# **A G E N D A**

## **Architectural Review Board**

**May 23, 2023 – 5:30 p.m.**

9A

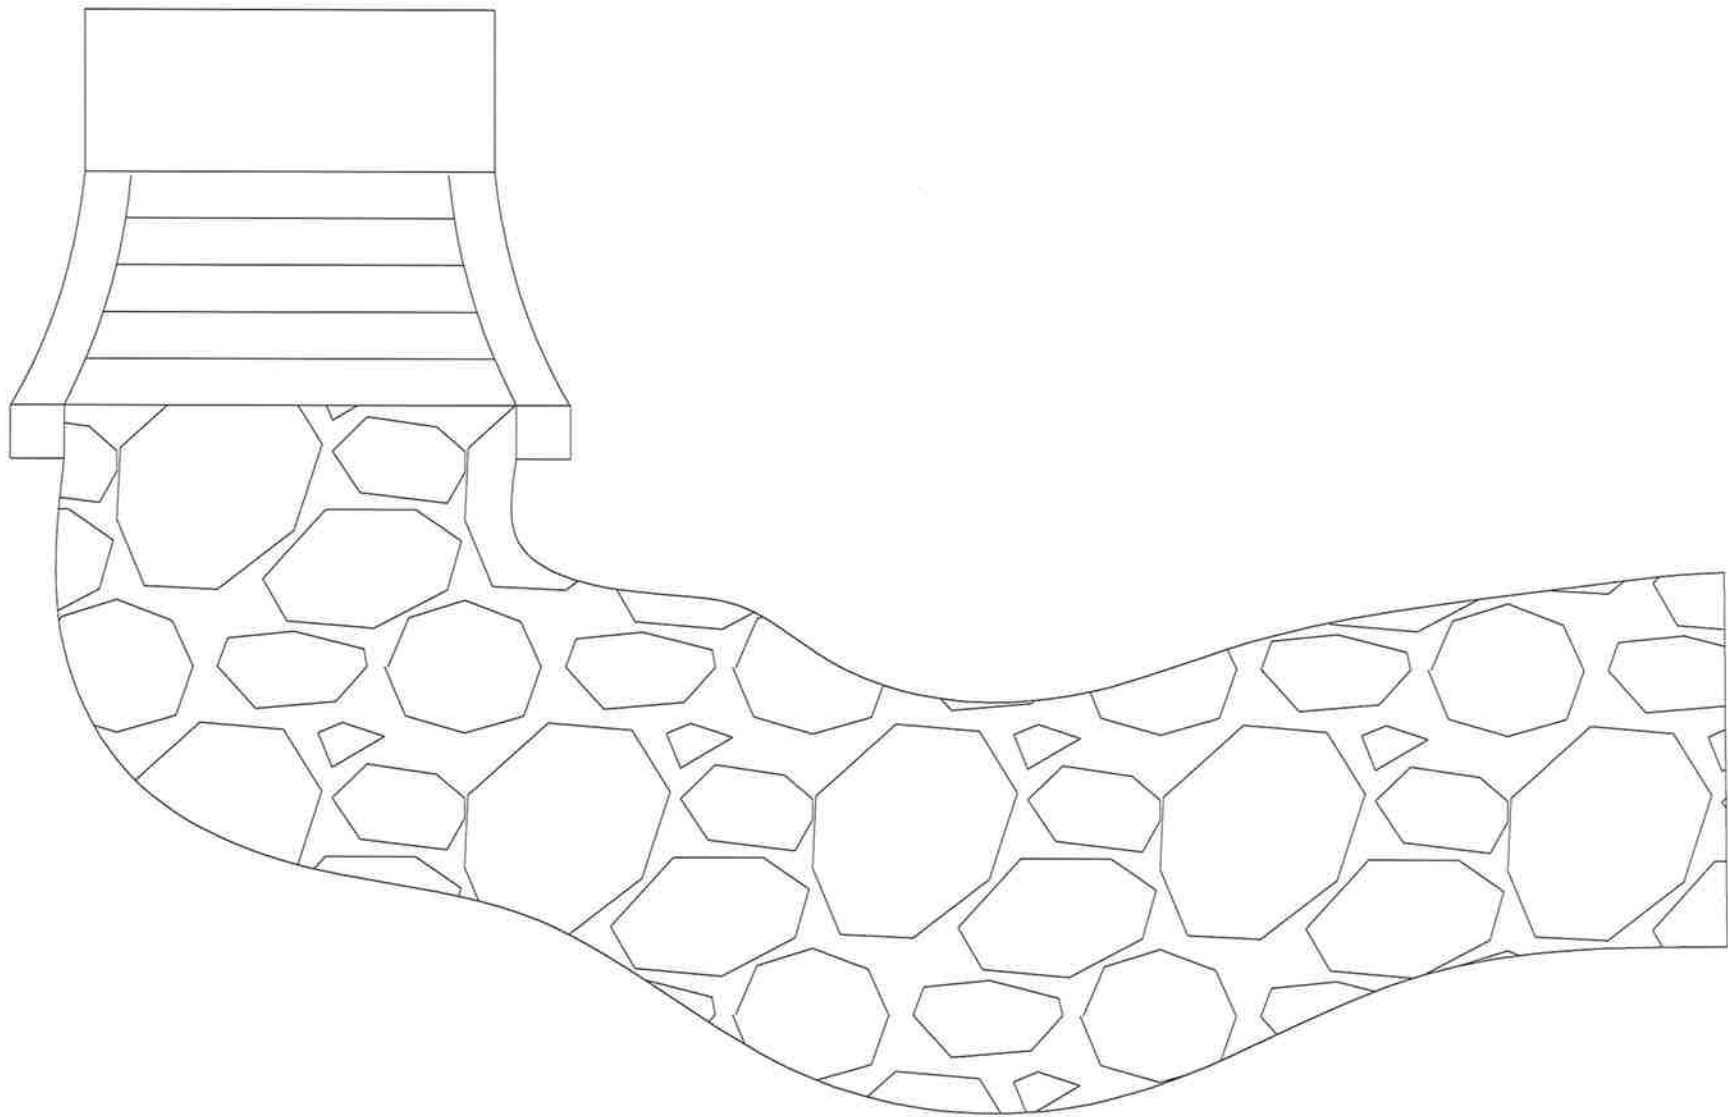
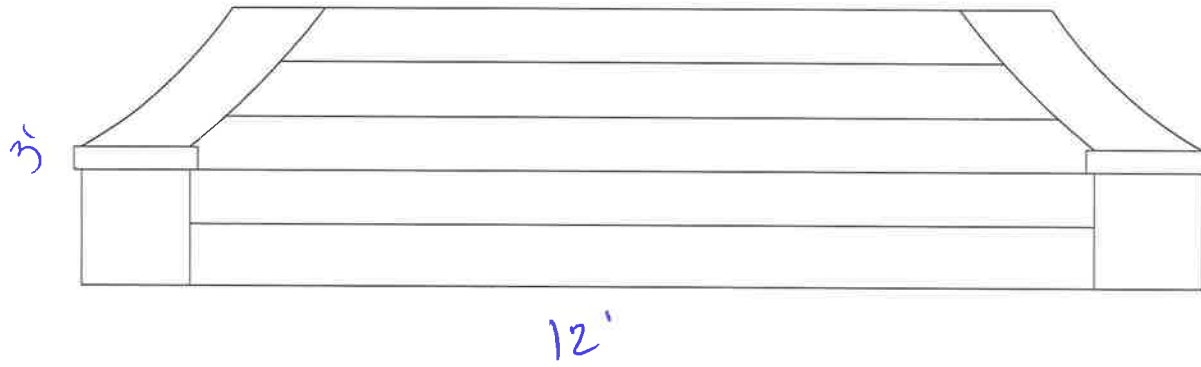
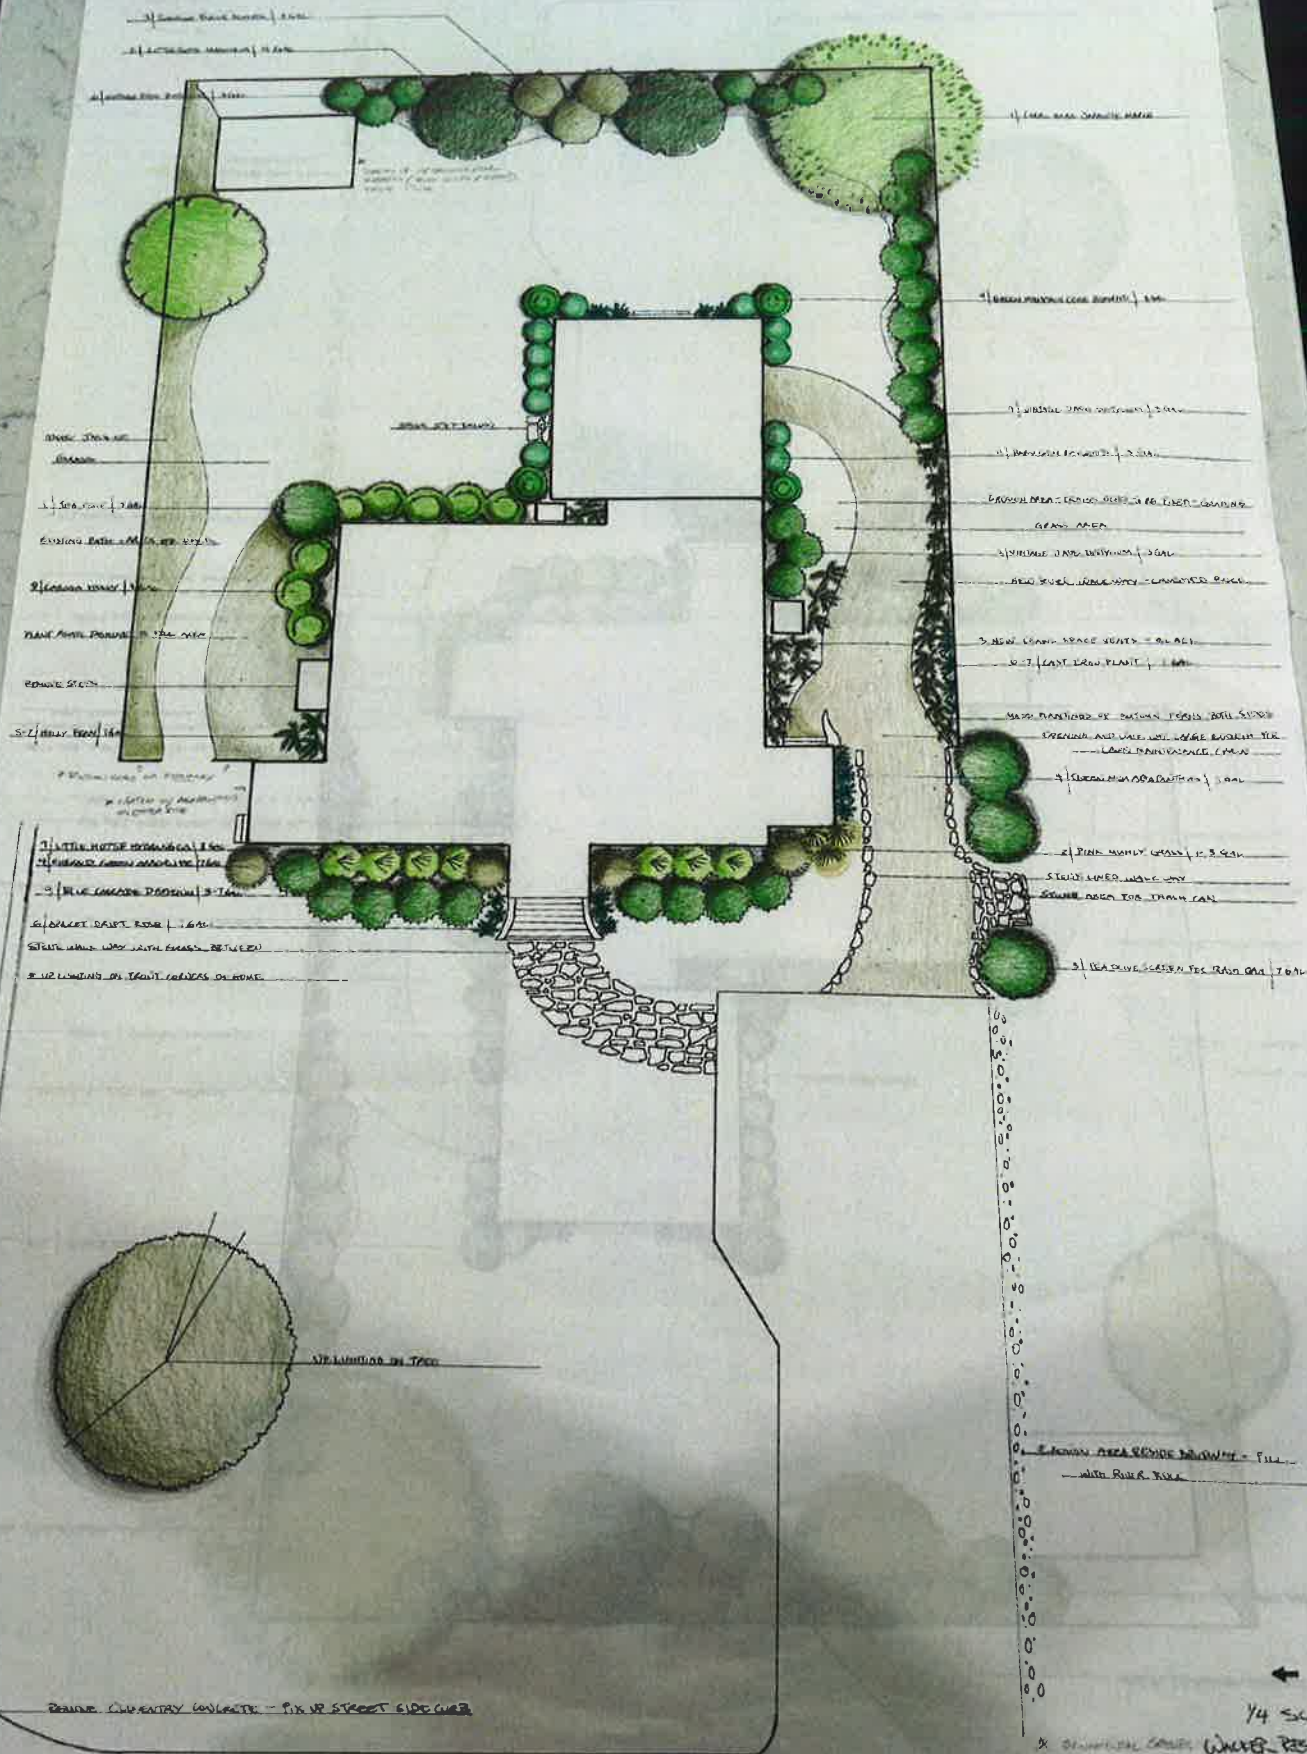
- The petitioner will be required to work with Charlie Harris in the Engineering Department regarding any work done on the right-of-way. Please ensure there is positive flow of drainage along the curb line.
